METHODOLOGY 2ND ASSESSMENT REPORT

REVISION OF VM0006 - CARBON ACCOUNTING FOR MOSAIC AND LANDSCAPE-SCALE REDD PROJECTS

REPORT N° 2013-9201

Report Title	Revision of VM0006 - Carbon Accounting for Mosaic and Landscape-scale REDD Projects
Report Version	Version 01
DNV Ref.	PRJC-430271-2012-CCS-USA
Assessment Criteria	VCS version 3.3
Client	Terra Global Capital LLC
Pages	24
Date of Issue	18 September 2013
Prepared By	Det Norske Veritas (U.S.A.) Inc. Climate Change & Environmental Services
Contact	155 Grand Avenue, Suite 500 Oakland, CA 94612 Tel: +1 415 318 3918
Approved By	-
Reviewed By	Edwin Aalders
Work Carried Out By	Andres Espejo (Lead Assessor)

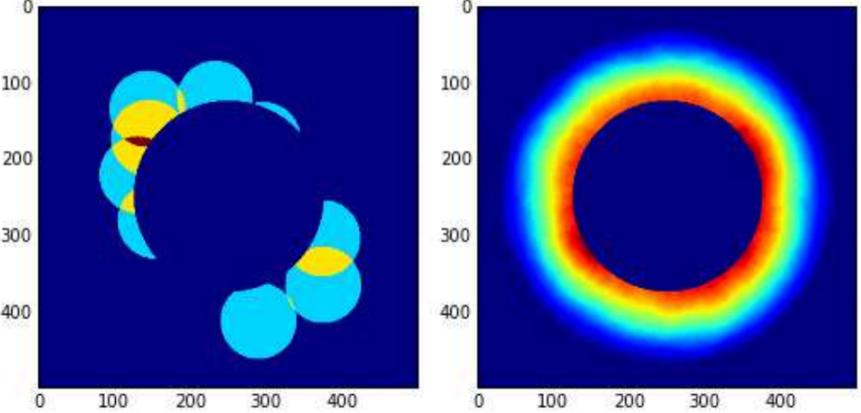
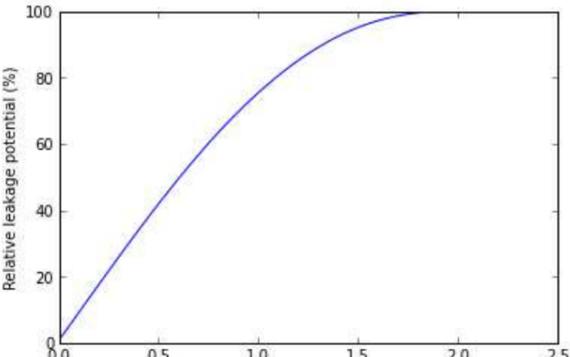
CAR10	<p>Element of MED Project Emissions Requirement VCS Version 3.3 Evidence (Report Section) MED Version 05, Section 8.2.6</p>	<p>Response #1 (MED Version 06)</p> <p>a) We have added the assumption that communities are collecting and consuming biomass fuel to the general quantification section in 8.2.5.2</p> <p>b) We have revised the equation by removing the provision to expand the biomass.</p>	<p>Assessment #1 (MED Version 06)</p> <p>The introduction of improved cookstoves would reduce emissions from two different sources:</p> <ul style="list-style-type: none"> • Non-CO2 emissions due to burning of woodfuel. • CO2 emissions due to the losses of carbon stocks linked to unsustainable harvesting.
